# HISTORIC AND DESIGN REVIEW COMMISSION

**HDRC CASE NO:** 2024-199  
**ADDRESS:** 1231 S ALAMO ST  
**LEGAL DESCRIPTION:** NCB 750 BLK 9 LOT 8 & SW 30 FT OF 7  
**ZONING:** RM-4, HS  
**CITY COUNCIL DIST.:** 1  
**DISTRICT:** King William Historic District  
**LANDMARK:** Individual Landmark  
**APPLICANT:** New Day Custom Homes  
**OWNER:** New Day Custom Homes  
**TYPE OF WORK:** Historic Tax Certification  
**APPLICATION RECEIVED:** May 30, 2024  
**60-DAY REVIEW:** July 29, 2024  
**CASE MANAGER:** Rachel Rettaliata

The applicant is requesting Historic Tax Certification for the property at 1231 S Alamo.

A-01

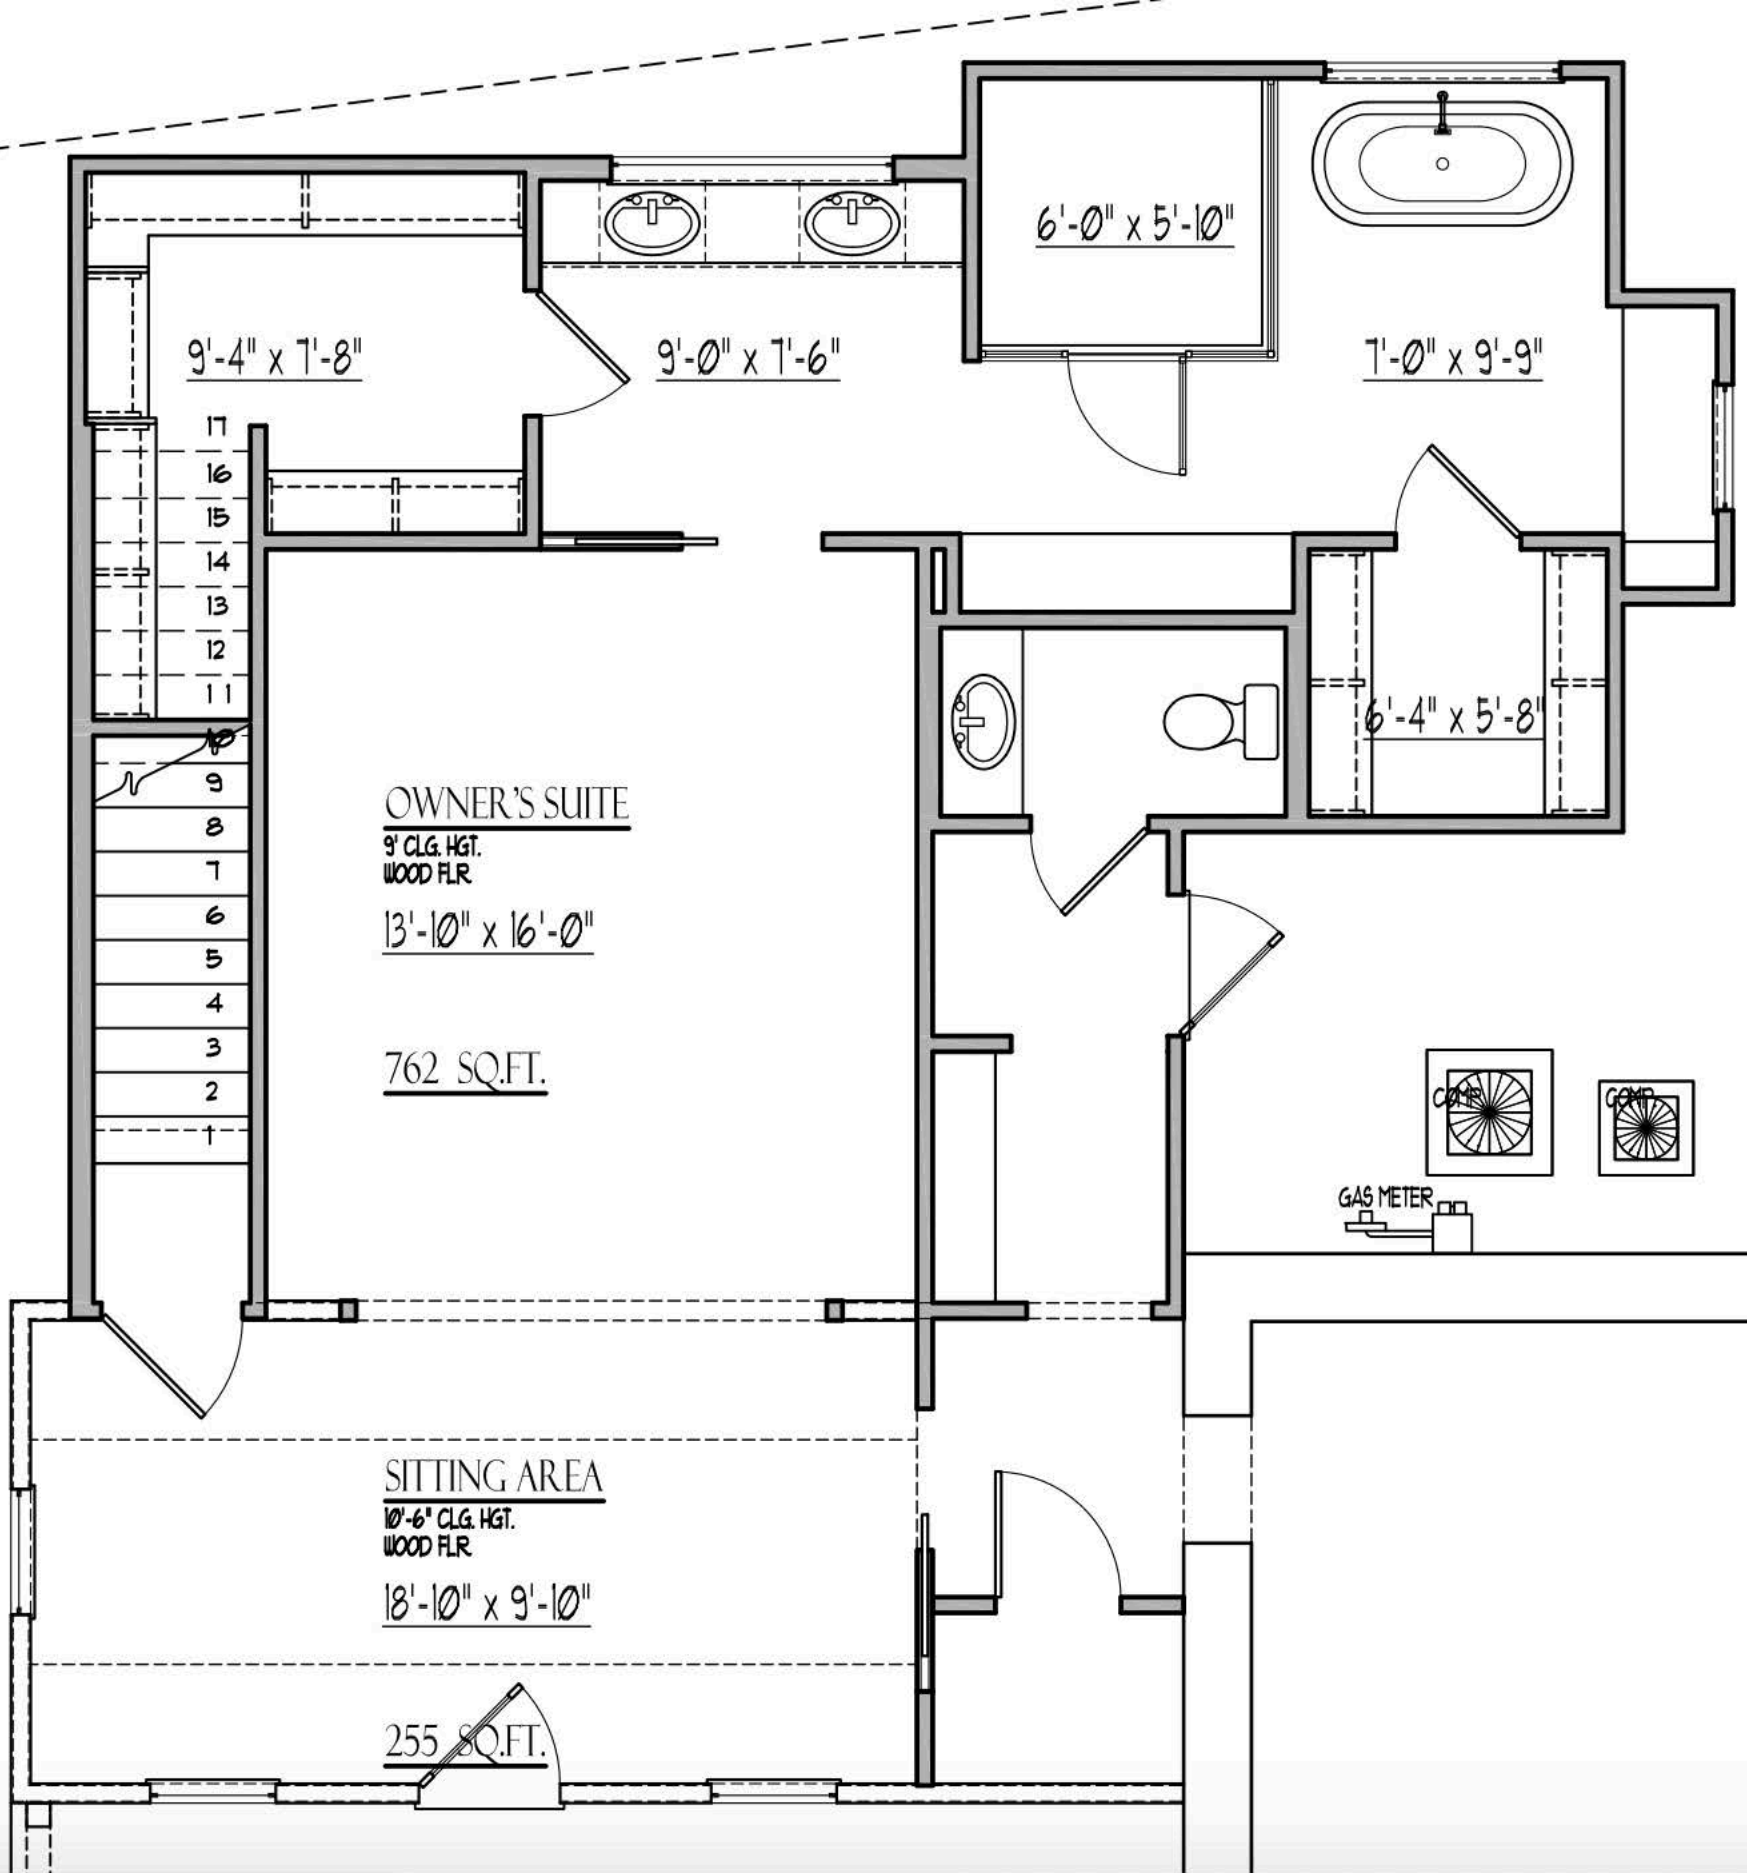
- a. The primary structure located at 1231 S Alamo is a 2-story, single-family residence constructed circa 1890 in the Folk Victorian style. It features a composition shingle hip roof with projecting front and side gables with decorative gable detailing, brick cladding, a wraparound front porch with classical column supports, and two-over-two wood windows. The structure features a 1-story rear addition that was constructed after 1955. The addition features a side gable standing seam metal roof with a salt box-style front porch roof facing Guenther Street, square columns with decorative brackets, wood cladding, and two-over-two wood windows. The applicants are constructing a new 2-story addition. The property is contributing to the King William Historic District. The applicant is requesting Historic Tax Certification.

- b. The scope of work includes a comprehensive interior remodel, window and door repair, roof replacement, plumbing and electrical upgrades, the construction of a new addition, and landscaping. Certificates of Appropriateness are required for all exterior scopes of work.

Staff recommends approval based on findings a through c.
